SUNNICA ENERGY FARM DCO EXAMINATION

Answers To Exq3 And Comments On Deadline 6 Submissions

SAY NO TO SUNNICA ACTION GROUP LTD

3 March 2023

Figure 1 River Lark and Sunnica East A

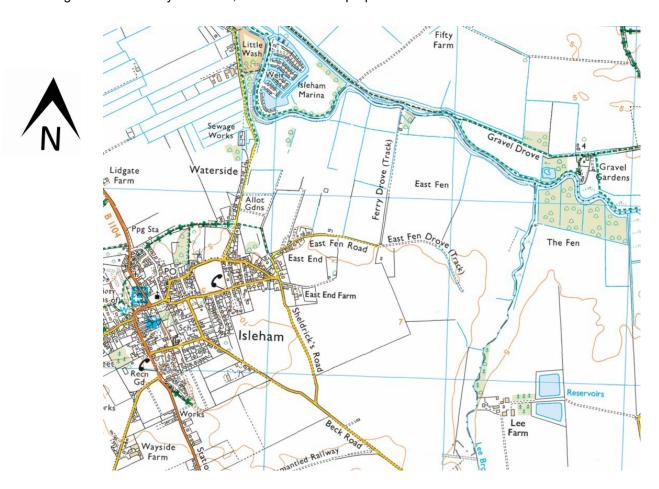
- 8. One example of a popular, "non-PROW" route, is East Fen Road in Isleham, which is in close proximity to the northern boundary of parcel E05, and which starts as a residential road, leading to a farm track (East Fen Drove, Figure 1). Because it is not a 'through road' it has little traffic and is well used locally by walkers and dog walkers who enjoy the tranquillity and unrestricted far-reaching views to the River Lark (North), Mildenhall (East) and Freckenham to the South.

- 18. As an example, the views from the elevated footpath along the River Lark heading from Isleham towards West Row are largely open and unrestricted (contrary to the description by the Applicant in paragraph 4.2.21). Users of the footpath (and also those travelling on the river) enjoy tranquil, unrestricted views to the East/South, similar to those shown in Viewpoint 1. This is particularly the case for the stretch between the Isleham Marina and the area of bank opposite Ferry Drove (site of the Spurgeon Stone/ ruins of the Old

Ferry Inn, Figure 1), which has long reaching views to the south and south east. A small area of woodland at the site of the Ferry Inn punctuates this openness, and then gives way to a further stretch of unrestricted views up to the area where the Lee Brook meets the river Lark.
